CITY OF GLENDALE, CALIFORNIA

DESIGN REVIEW STAFF REPORT – HILLSIDE SINGLE FAMILY

July 9, 2024 <i>Decision Date</i>	3223 Kirkham Drive <i>Address</i>
Administrative Design Review (ADR) <i>Review Type</i>	5658-022-021 <i>APN</i>
PADR-002614-2023 <i>Case Number</i>	Vardan Kasemyan <i>Applicant</i>
Roger Kiesel, AICP <i>Case Planner</i>	Jack Bekian <i>Owner</i>

To construct a 1,554 square-foot basement below a recently approved (but not yet constructed) 3,850 square-foot new two-story residence located on a 19,052 square-foot lot, located in the R1R, FAR District III zone. The size of the residence, including the basement, will be 5,404 square feet. The existing 2,599 square-foot residence, which will be demolished, was constructed in 1974.

1 GRADING PLAN
3/32" = 1'-0"

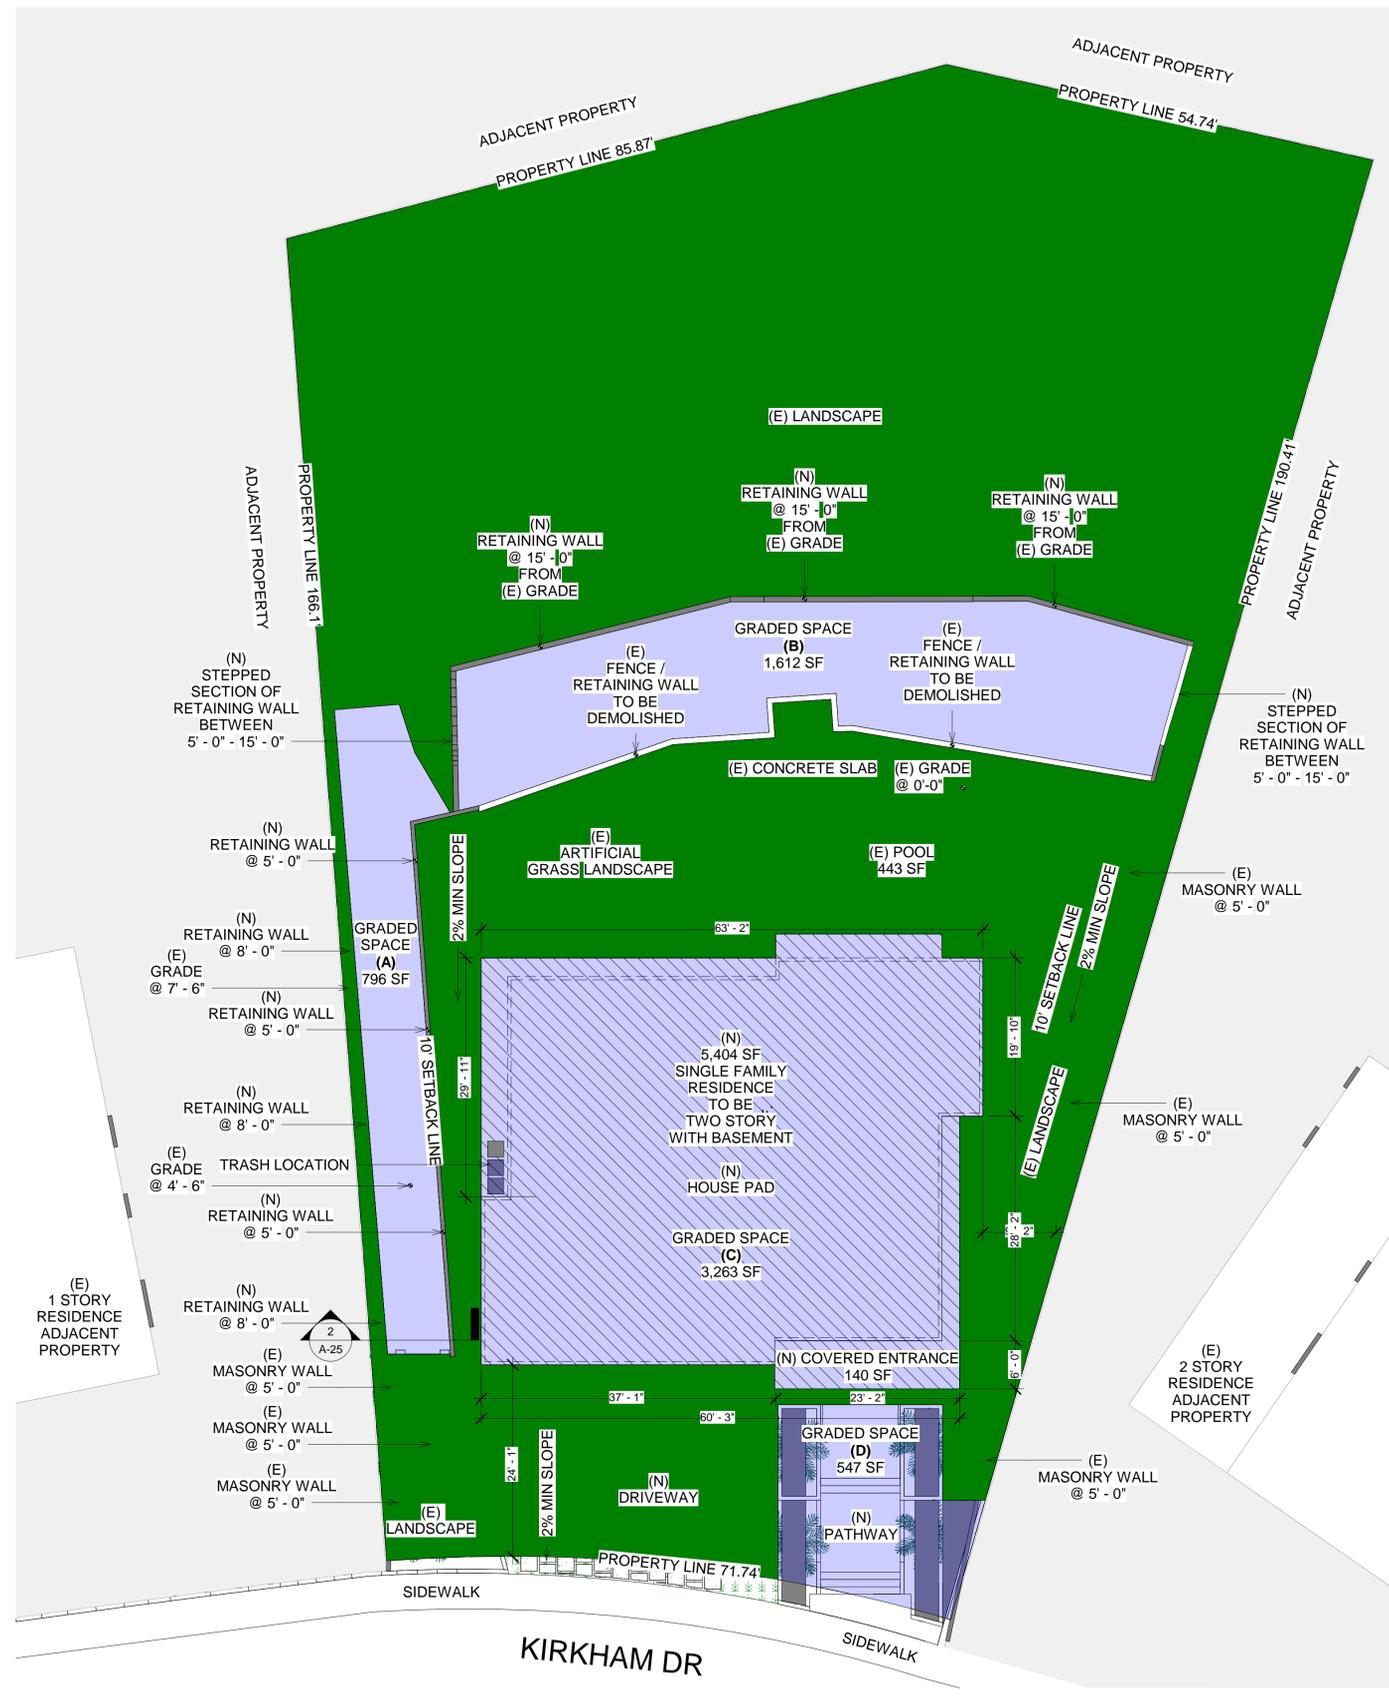
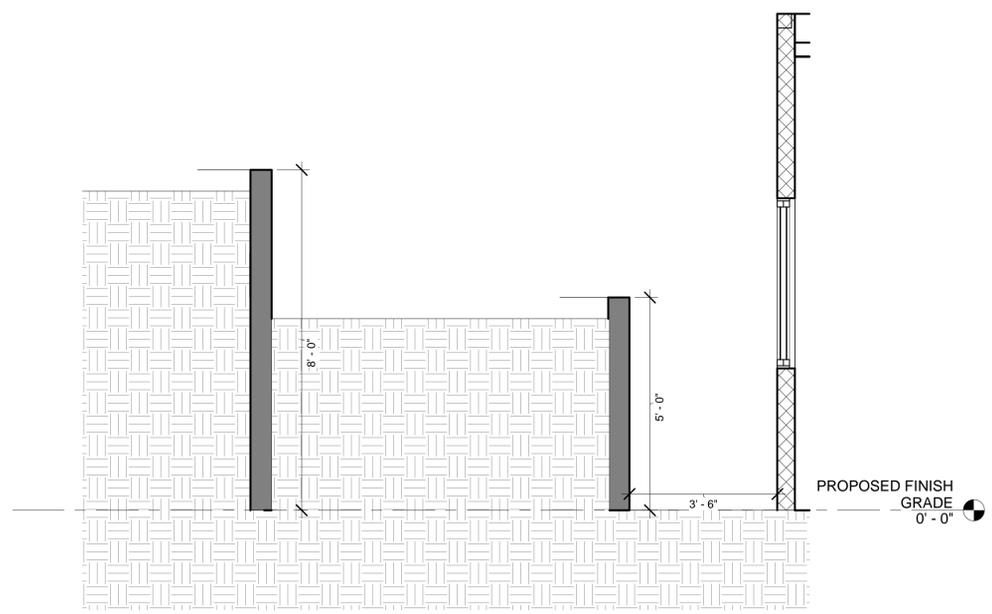
As part of the revisions to the project, a new retaining wall is proposed in the rear yard. Retaining walls located within 5 feet of an interior property line can be no more than 3 feet high. Retaining walls hidden from view from a public street by primary or accessory structures that are upslope from public street access can be up to 15 feet high. Retaining walls which do not meet either criteria can be a maximum of 5 feet high. As proposed, portions of the retaining wall do not comply with these standards. A condition of approval will require amending these plans so that compliance is achieved.

- As conditioned, proposed retaining wall plans shall be amended to comply with the standards in the Zoning Ordinance.

1 LANDSCAPE & IRRIGATION PLAN
3/32" = 1'-0"

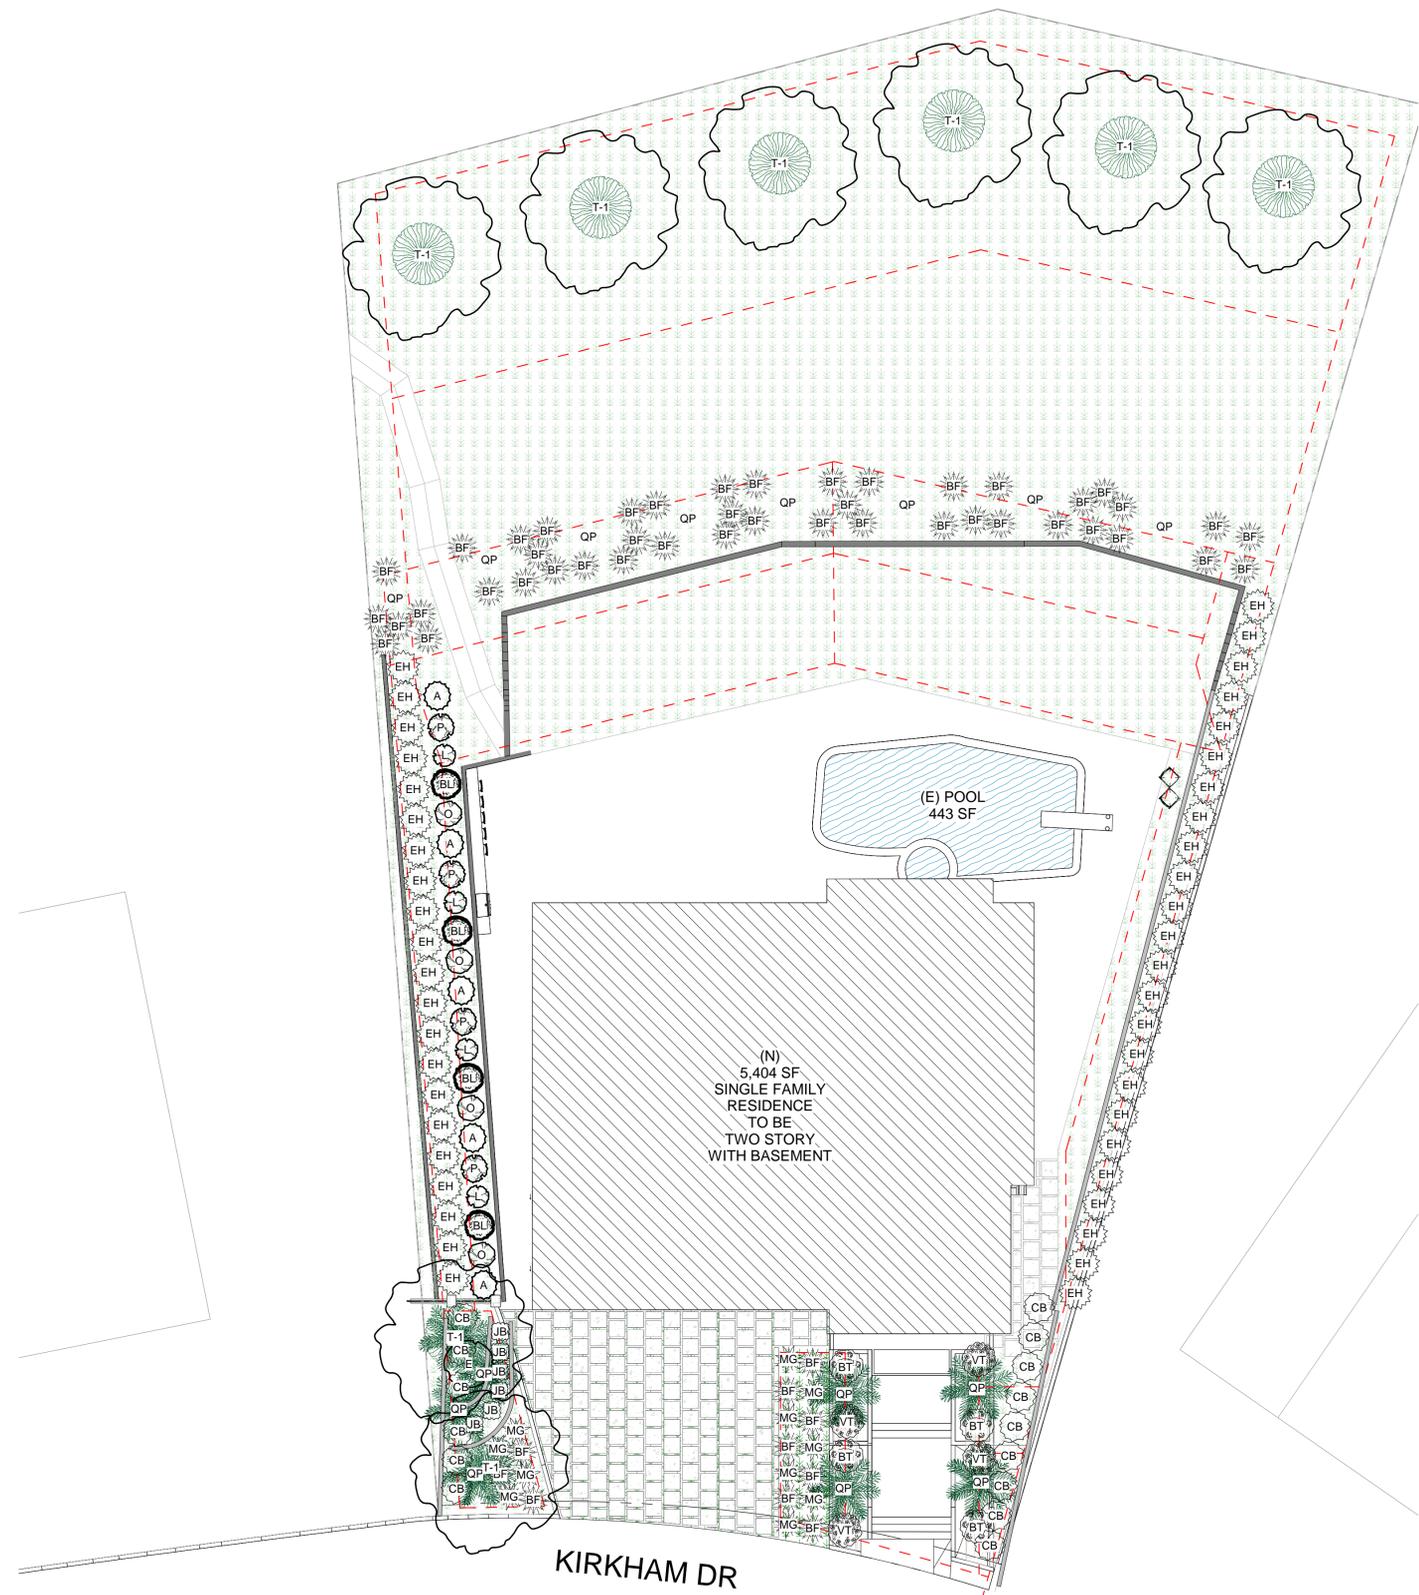
Landscape design should provide a naturalistic look, complementary to the building design and minimizing paved areas. To that end, staff is recommending several alterations to the design of the landscaping to be more consistent with the Landscape Design Section of the Hillside Design Guidelines.

Trailing plants should be added to areas adjacent to existing/proposed retaining walls and front yard planters to allay the presence of these features.

1. The landscape plan shall be amended to include the reduction of hardscape (to no more than the width of the entry door/sidelight), or increase in permeable surface area at the front walkway, addition of two shade trees within the front yard and trailing plants adjacent to retaining walls and planters and a more naturalistic design of the rear yard behind the retaining wall. Revised landscape plans shall be reviewed and approved by staff.
2. Retaining wall plans shall be amended to comply with the standards of the Zoning Ordinance.
